Re: Lemon Creek; POA-1983-20-N

Kindly consider this letter and the new drawings prepared by R&M Engineering to be a modification to the original application.

LEMON CREEK CHANNEL EXCAVATION

CROSS-SECTION @ HAUL ROAD

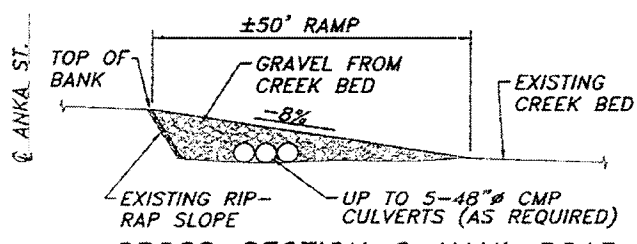
Access Road Location and Dimensions. This has changed. If trucks enter the stream channel before March 15, 2007, up to five steel culverts four feet in diameter and up to 40 feet long will be installed at the entry point at the end of Ralph's Way, covered with material removed from the channel and armored with rip-rap or large shot rock to provide access to the work area. After May 15, 2007, the stream will be routed away from the entry point and the structure will be removed prior to June 1, 2007. Thereafter, it is intended that the entry point will be dry during time periods in which work will occur and culverts will no longer be needed. If, however, flow does occur at the entry point and it is necessary to maintain that flow to protect incubating eggs, the culverts will be included when the structure is re-installed. All materials used in building the structure will be stored above the ordinary high water line when not in use. A drawing showing the location and dimensions of the structure with culverts is submitted herewith.

LEMON CREEK CHANNEL EXCAVATION

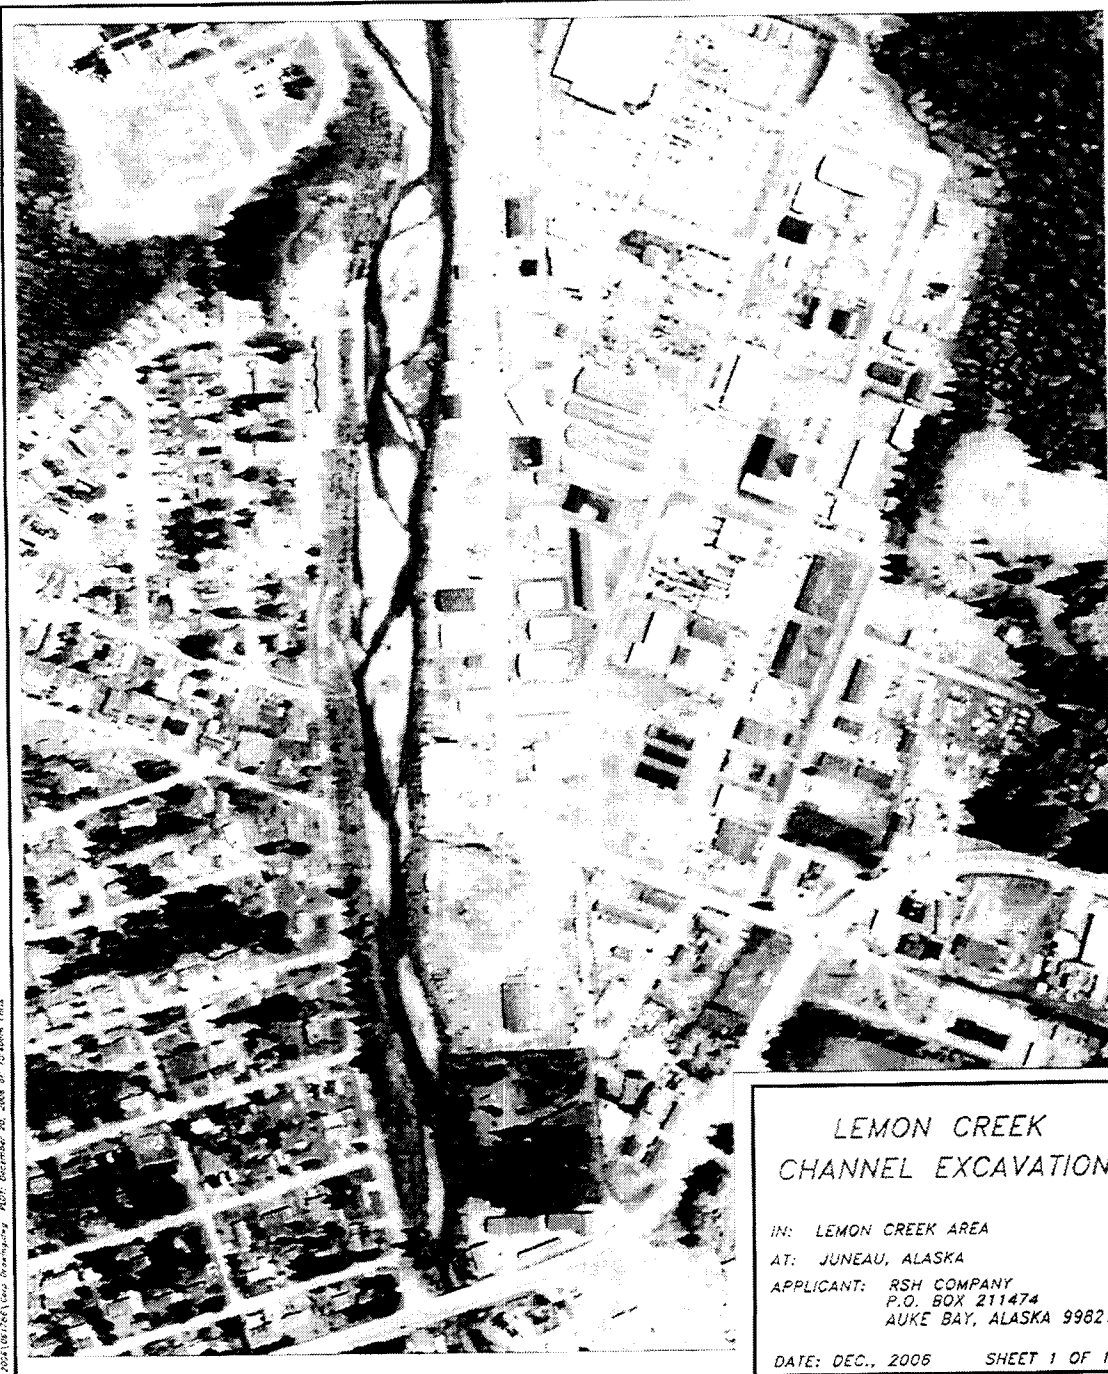
At the second meeting, a somewhat different approach was developed. Mining would begin by removing materials from exposed bars and the ground below them which do not contain fish eggs. This will create new low areas within the channel. At the conclusion of this activity and after fry have emerged, the main flow of the stream will be routed through these areas. This will create new dry areas where spawning would not occur and which would be available for removal of material. This process would continue until 200,000 cubic yards of sand and gravel are removed from the site. At that point, ADNR habitat biologists would complete a re-evaluation of the endeavor to determine whether it could continue. Berms may not be necessary but could be desirable to block leaks and aid in controlling the flow from one newly-created low area to another. Accordingly, the modified proposal eliminates the long berm originally planned and replaces it with a series of much smaller parallel berms which connect the new low areas and facilitate flow from one to another. At the conclusion of all mining, woody debris presently in the channel would be collected at several places to create "hard points" which would promote the formation of bars. The amount of wood re-placed in the channel would not exceed 100 cubic yards. Anything unused would be removed to a location above OHW. Drawings showing the areas where mining would occur on alternate years, the location of the parallel connecting berms, and typical sections of each are also submitted herewith.
